~~Draft~~ System Strength Impact Assessment Guidelines

Version: ~~N/A~~2.0

Status: ~~Draft issued for consultation on 12 January 2023~~ — FINAL

This document shows changes made between the draft and final SSIAG.

Figure 3 System strength impact assessment process within connection process

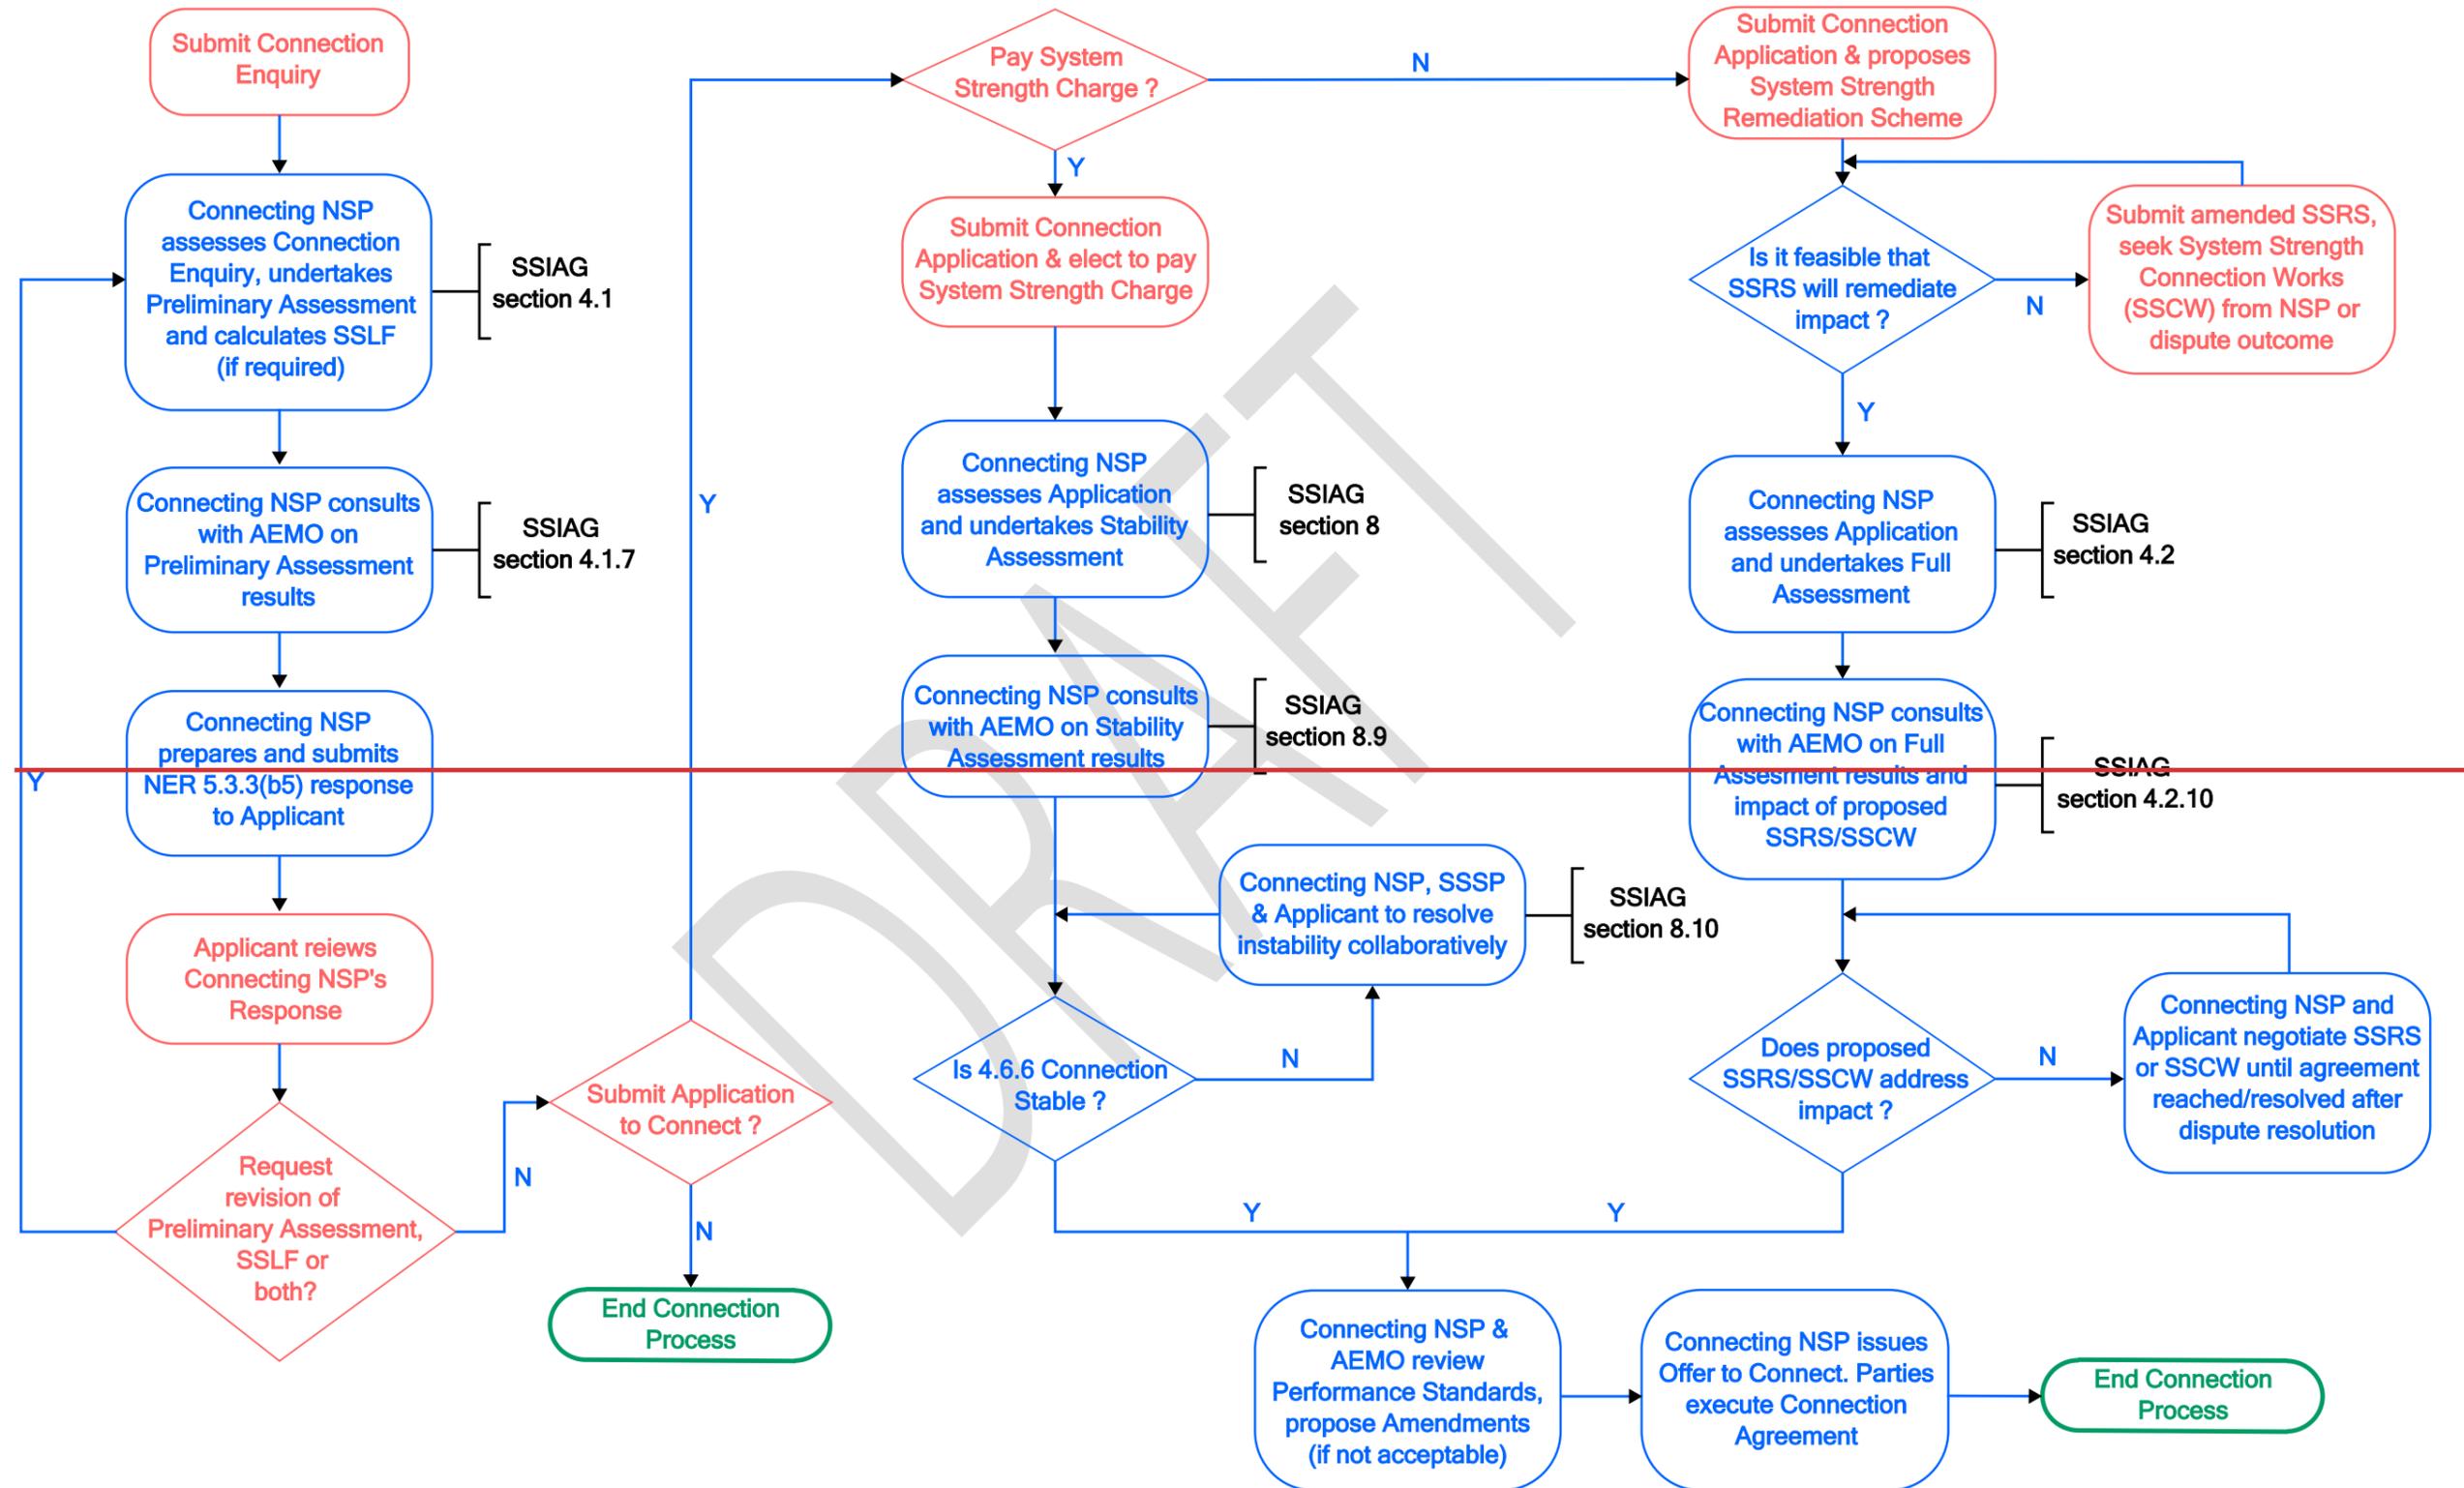
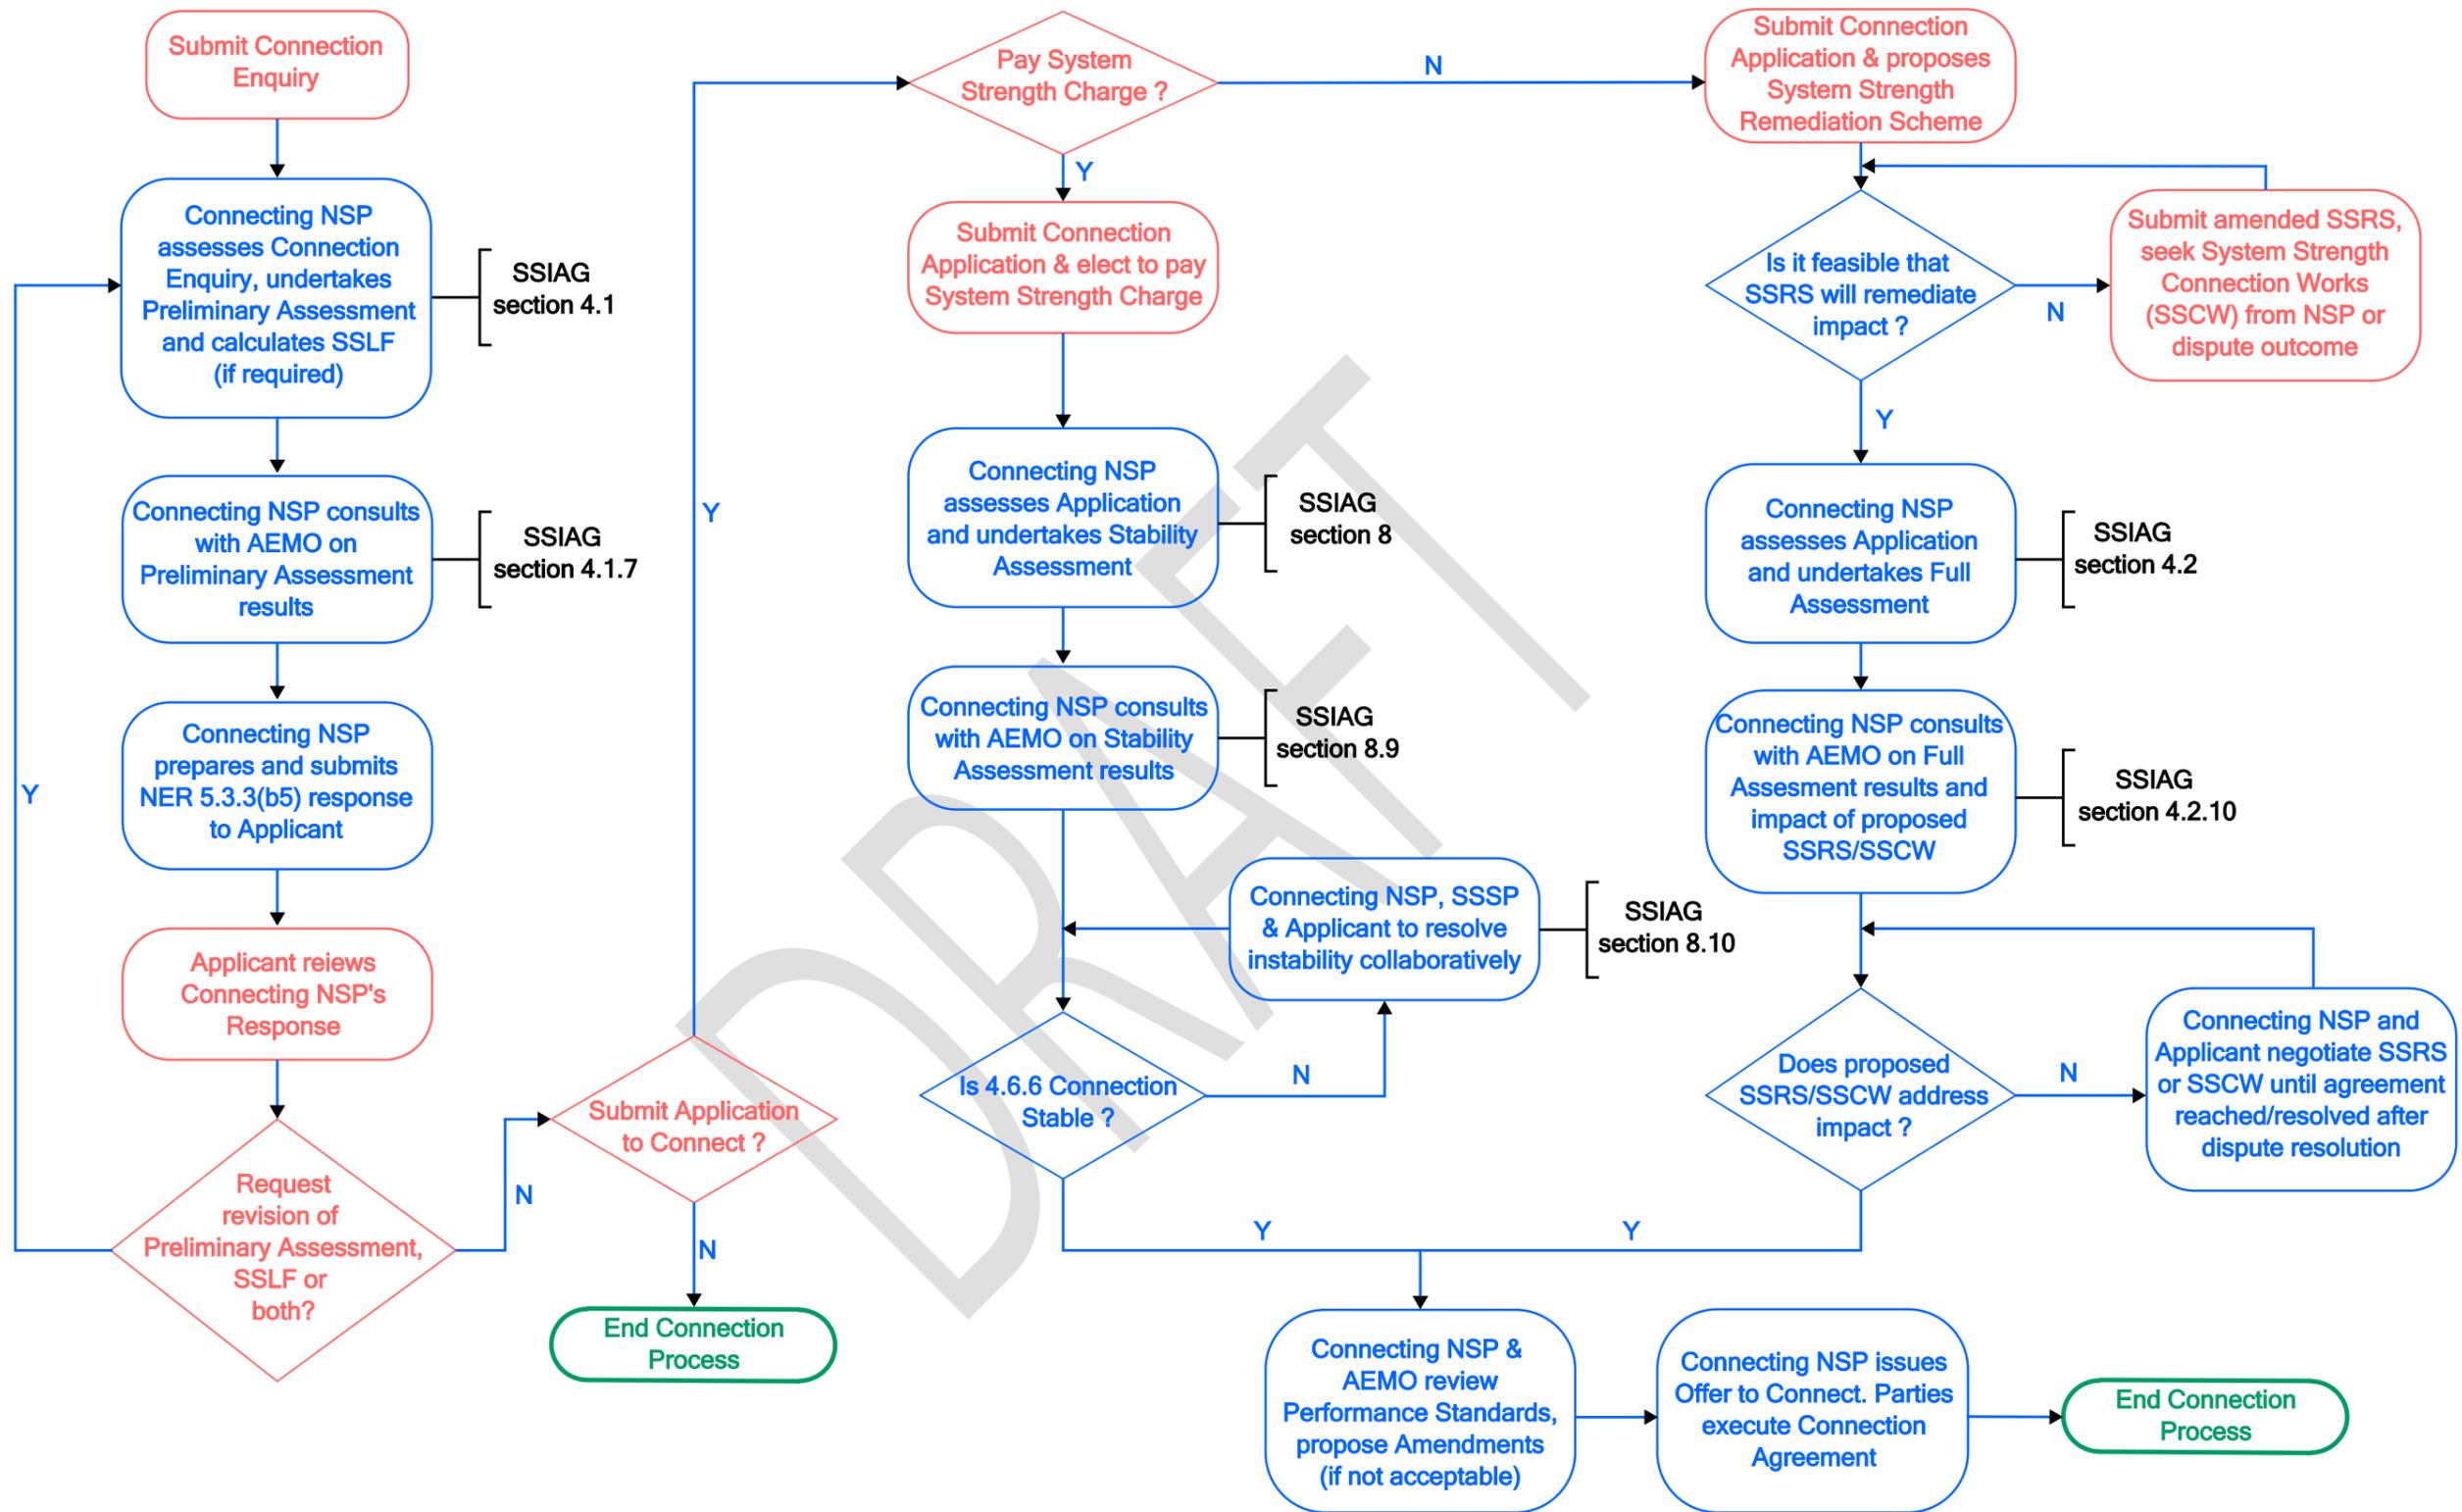
- (c) 4.6.6 Connections that are comprised of alterations ~~Alterations~~ to *plant* initiated under NER 5.3.9 or 5.3.12 do not follow the same NER connections process as ~~those that are comprised of new plant.~~ AEMO considers a, but their system strength impact is also assessed under NER 5.3.4B. For these purposes, where a proposed alteration to plant is a 4.6.6 Connection (refer to section 2.3):

- (i) the Applicant should request a Preliminary Assessment¹¹ prior to making a formal submission under NER 5.3.9(b) or NER 5.3.12(b) ~~as part of initial discussions with its Connected NSP, which can be considered comparable to a connection enquiry as shown in Figure 3; and~~

- (ii) the Applicant's submission under NER 5.3.9(b) or NER 5.3.12(b) is equivalent to an application to connect, as an Applicant is required to either provide an SSRS with its submission or state its election to pay a system strength charge (SSC), instead. AEMO considers that¹², therefore the system strength impact assessment to be carried out by a Connecting NSP following receipt of ~~such that~~ submission must be a Full Assessment or a Stability Assessment, as applicable, ~~so the process must be taken as being similar to that shown in Figure 3 following the application to connect.~~
